**GRCA Hydrogeology Comment Response
Proposed Residential subdivision
3852 Ganaraska Road
Campbellcroft, Ontario**

Project 213-8438

The Greer Galloway Group has received review comments provided by hydrogeology staff at the Ganaraska River Conservation Authority (GRCA) for the proposed Garden Hill Residential Development. These comments are reproduced below:

Figure 5 – Predicted change in groundwater recharge (mm/a). The dashed lines represent an approximate zone of influence around on-site wetland features

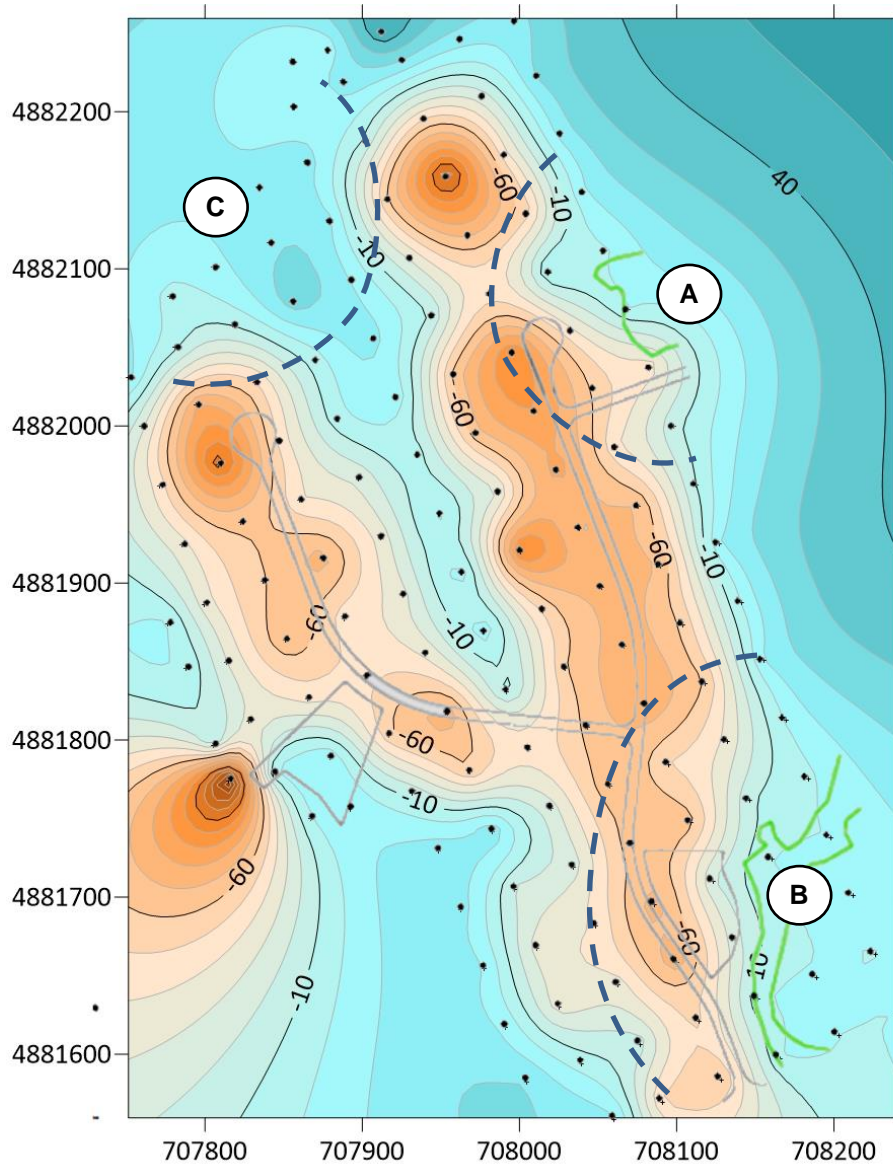
- 1. As stated previously, the hydrogeological report should speak in more detail to the potential impacts of the development site, including reduction in infiltration potentially leading to reduced interflow and baseflow discharge, raised or lowered water levels in shallow aquifers, changes in shallow groundwater flow direction, and creation of preferential pathways that may increase susceptibility of contamination in the subsurface. A figure or schematic indicating the movement of subsurface water would be beneficial to clearly show the difference between pre- and post development preferential pathways. This is especially important since the site contains a wetland, which is likely linked to the groundwater it receives. It is noted that the groundwater level within an aquifer fluctuates constantly in response to rainfall, evapotranspiration, barometric pressure, groundwater movement, and groundwater pumpage. As such calculating hydraulic gradients and groundwater velocity would quantify those changes. A description and figure of the proposed site alteration that clearly outlines groundwater elevations and change in subsurface drainage patterns should be addressed.*

Overall, reductions in recharge range from 10 to 60 mm/a under the assumed conditions which ignore any lot level enhanced infiltration as well as infiltration in roadside ditches and stormwater ponds. The change is distributed across the site in a roughly even manner which suggests that overall groundwater flow directions are unlikely to be significantly changed although localized increases and decreases in recharge will be reflected in changes in the water table and slight changes in localized flow directions. Such changes are predicted to occur on a scale too fine to be modelled.

The figure shows the approximate locations of two on site wetland areas (A and B) as well as an

intermittent water course draining the wooded EP zone in the north part of the property (C). Potential effects of reduced infiltration within the zone of influence surrounding these features warrants closer attention (see Comment 6).

Figure 6 – Predicted change in groundwater recharge showing priority areas for enhanced infiltration

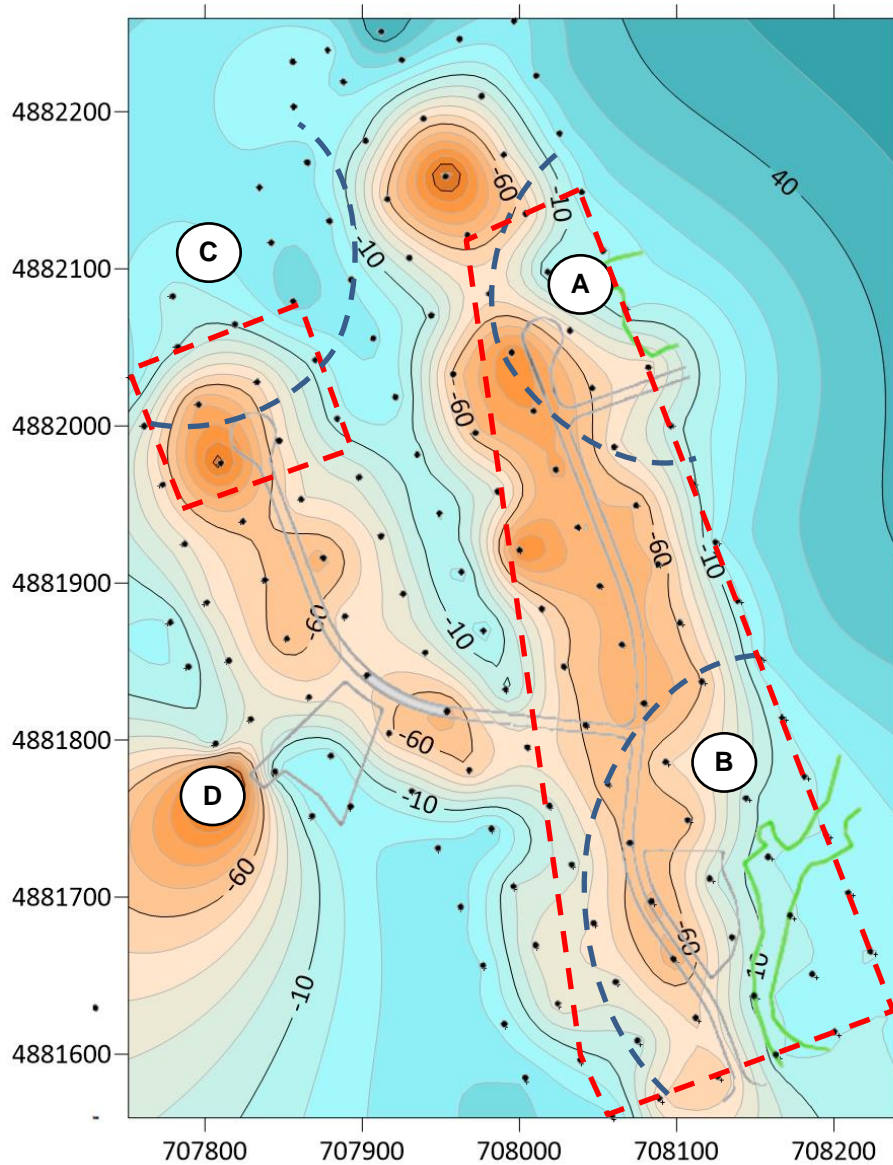
- 6. As much as possible, calculations should estimate the amount of infiltration necessary to maintain pre-development conditions. Detailed information on the proposed mitigation measures should be provided to account the loss of infiltration. These details should include location of enhanced infiltration, the volume/rate and condition of the soils to support water*

being infiltrated. This is especially important as the site contains a wetland – Please demonstrate that there will be no negative impacts on the natural features or their ecological functions due to the development.

Portions of the site that should be prioritized (i.e., those within the assumed zone of influence of the wetlands and intermittent water course) are shown below. The slight reduction of recharge over the balance of the site would not have any adverse ecological effects since the shallow flow enters the North Ganaraska River which is impounded by a dam in the area adjacent to the site and does not provide suitable spawning habitat for sensitive cold water species such as brook trout (*Salvelinus fontinalis*) which require upwelling groundwater flow through streambed gravels for spawning.

We note that the modelled change in infiltration at Location D is largely an artifact of the kriging algorithm used to generate the contours.

Within the identified areas we recommend the use of enhanced infiltration measures to infiltrate clean roof runoff for each lot. Direct infiltration avoids water losses to evapotranspiration and runoff and it is possible, in principle, for lot level infiltration to offset infiltration losses resulting from impervious paved areas. Direct infiltration of roof water would always be predicted to have its maximum benefit during the summer months when evapotranspiration losses are at their highest and when wetlands would be under the greatest stress.
